Service Bulletin

Subject: RATTLE NOISE FROM FRONT DOOR GLASS	Bulletin No: 09-011/13
	Last issued: 04/17/2013

2013-2014 CX-5 vehicles with VINs lower than JM3KE*****300112 (produced before December 28, 2012)

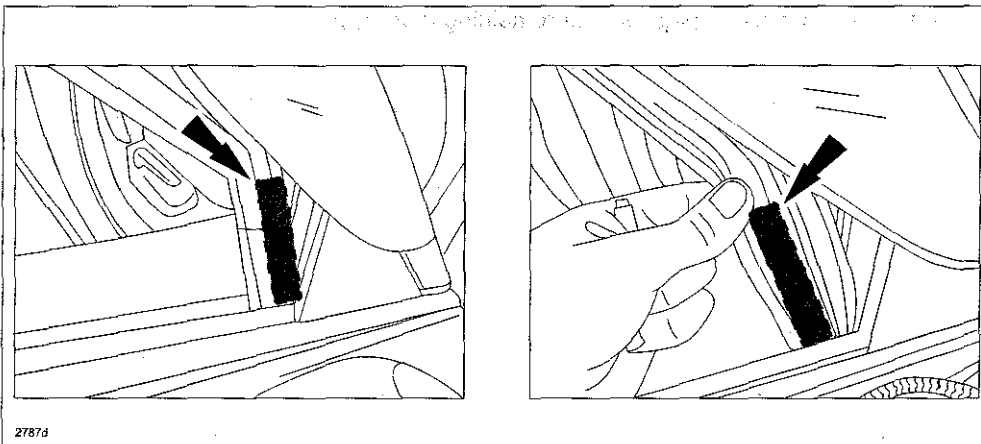
- If the noise goes away, proceed to the next step.
 - If the noise does not go away, this service bulletin does not apply. Troubleshoot the noise according to section 09 (Body and Accessories) of the MS3 online instructions or the Workshop Manual.
2. Open the door glass fully (right side glass run channel shown below).
 3. Pull the glass run channel off of the door frame.

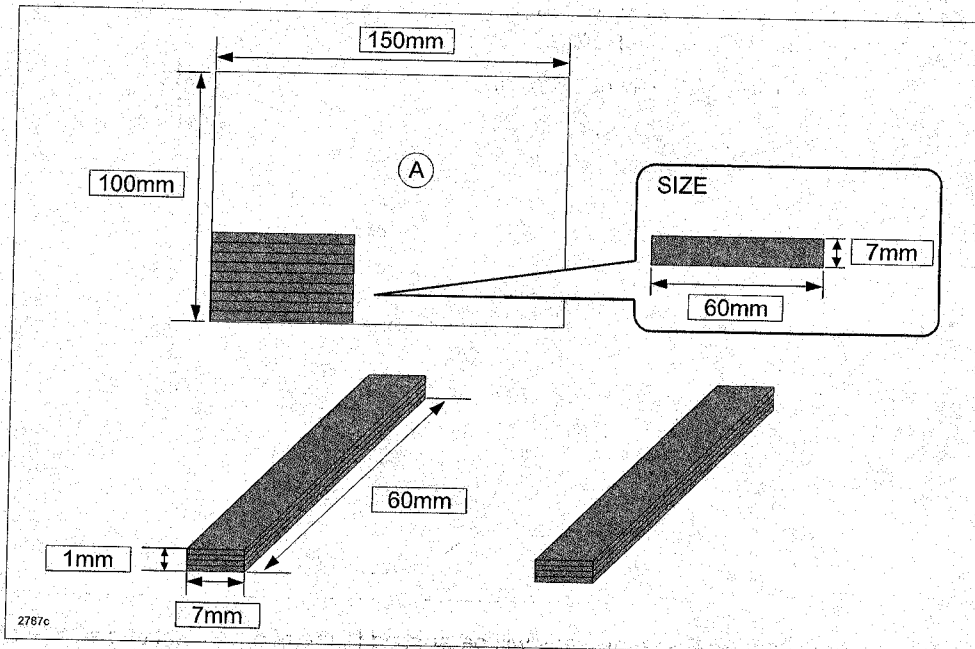
4. Degrease the glass run channel where the pads will be applied to the two (2) locations shown below.

5. Apply an adhesion promoter (one that is suitable for use on plastic) to the two (2) locations where the pads will be attached.

- Obtain adhesion promoter locally.
- Recommended adhesion promoter: 3M K-540NT, K500 or 4298UV. If these products cannot be obtained, any adhesion promoter suitable for plastic can be used.

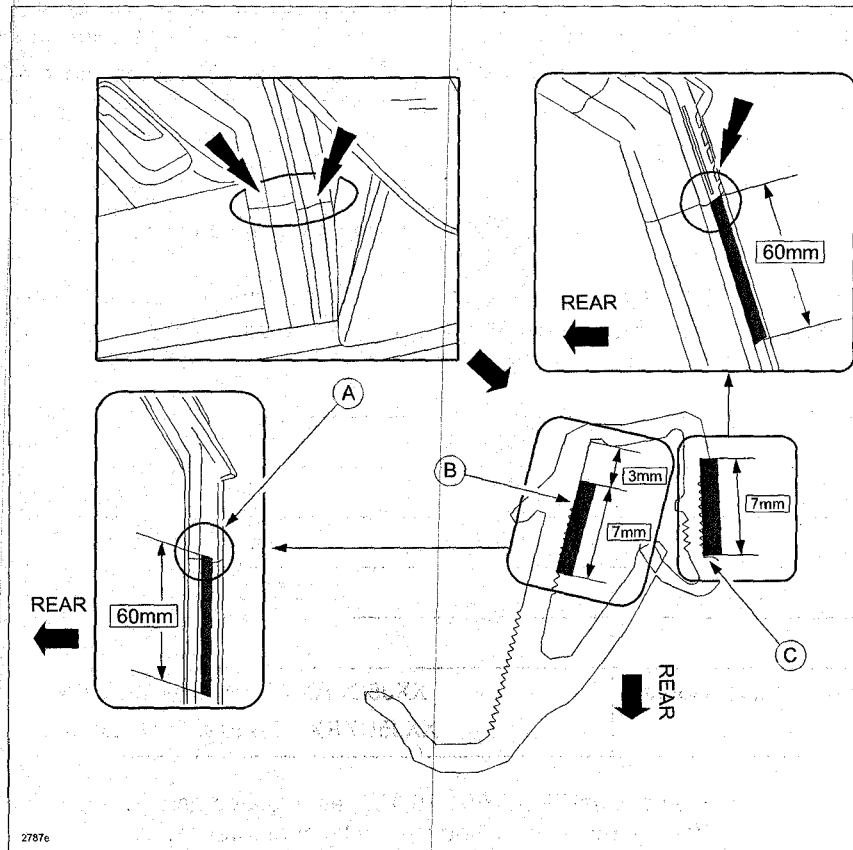
10. Following steps a-c, attach both pads onto the glass run channel positioned below the molded joint line.
 - a. Align the upper edge of the first pad with the molded joint line (A).
 - b. Position the first pad 3mm away from the back of the glass run channel (B).
 - c. Attach the second pad by aligning it with the bottom of the outer line (C).
